# PARTS & SERVICE NEWS

REF NO.	AT00205A
DATE	Sep. 6, 2001

**SUBJECT:** REPAIR OF T/C STATOR BUSH ON HD465/605/785/985-5

**PURPOSE:** To introduce modification procedures to repair the torque converter stator bushings on HD465-5, HD605-5, HD785-5 and HD985-5 dump trucks

Fig. 1 Cross-sectional view of the torque converter

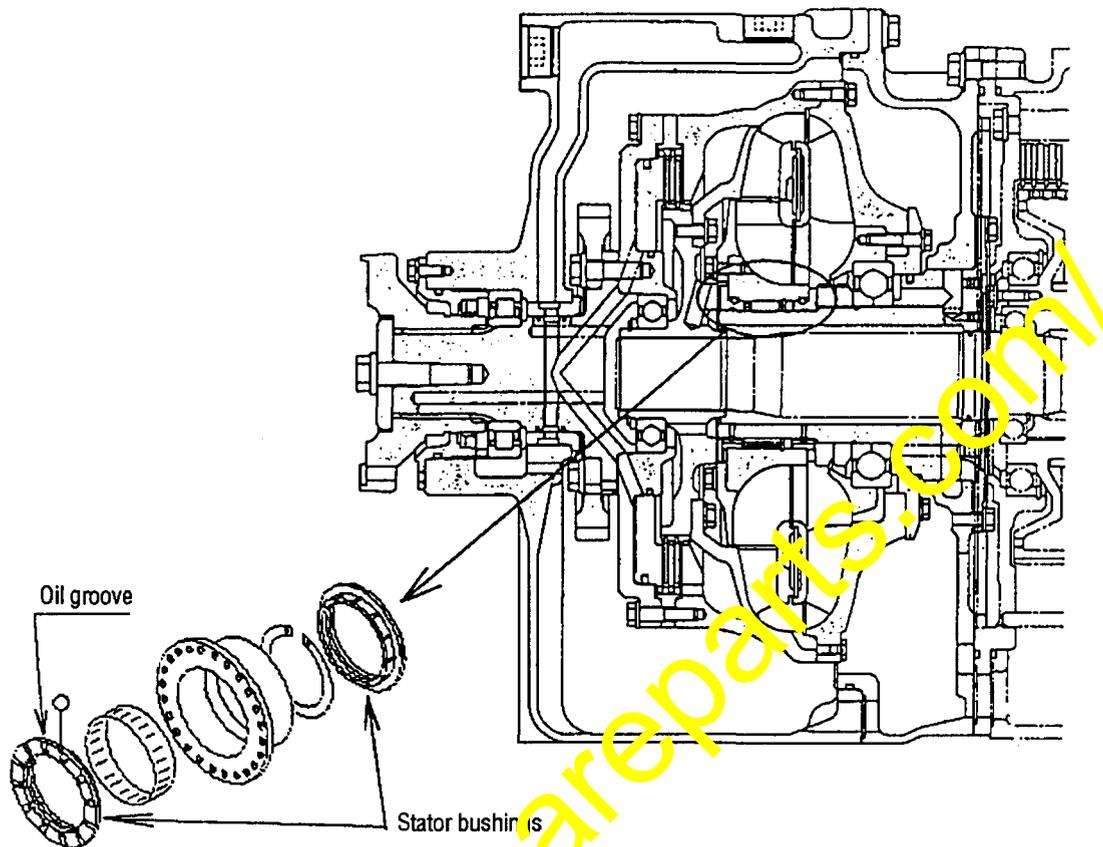
- (1) Torque converter stator bushings with insufficient chamfering for the side edges of the oil groove were used when some of the aforementioned dump trucks were manufactured and these vehicles have been shipped out already.  
(Refer to page 2 for details.)

- (2) When these vehicles are in operation, the end face of the bushings may wear abnormally by run out of the oil film.  
Although performance of the vehicle will stay normal during initial stage of wears (within 1,000 hours), as the wear progresses, horse power shortage or similar abnormality will occur.

The side edges of the oil groove of the torque converter stator bushings are now properly chamfered to facilitate oil entry, thus preventing occurrences of running out of film lubrication and eliminating the cases of early stage wears of the bushings.

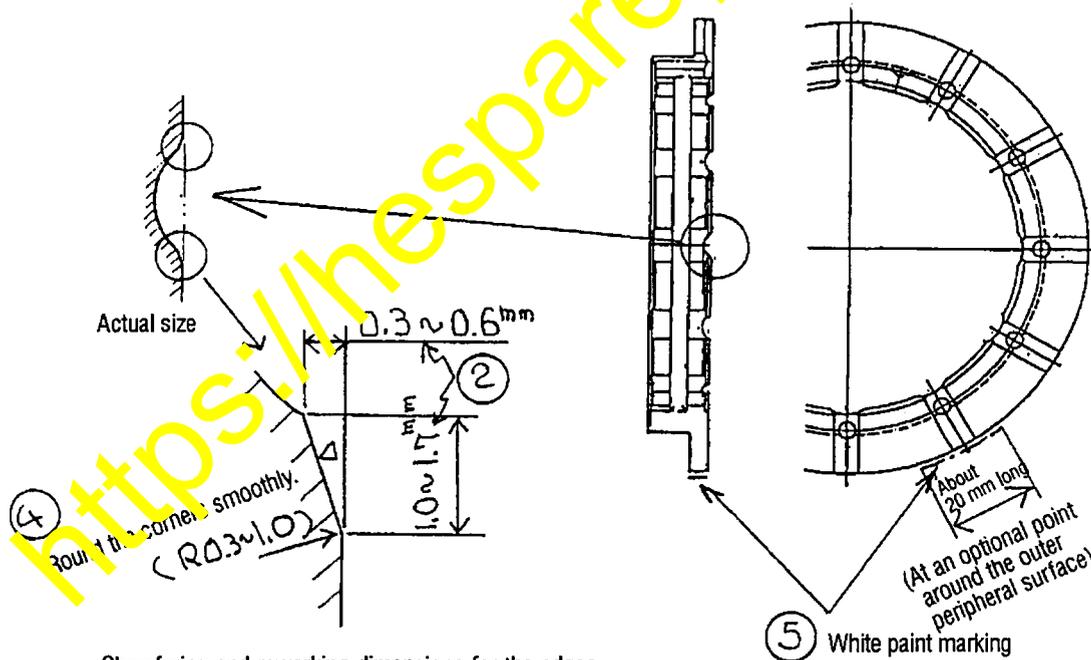
- 1 Necessary tools and devices
  - a. Files    b. Emery paper (#200) (Necessary man-hour for this modification: 0.5 hours)
- 2 Grind the edges of the oil groove to the following dimensions using a file.
- 3 Remove burrs and flashes from the corners using a file.
- 4 Finish the corners to smooth surfaces using emery paper.
- 5 After finishing this modification, apply white paint marking of about 20 mm long on the outer peripheral surface of the bushing.

Chamfering and reworking dimensions for the edges of the oil groove (Make the modification using the above dimensions as the reference dimensions.)
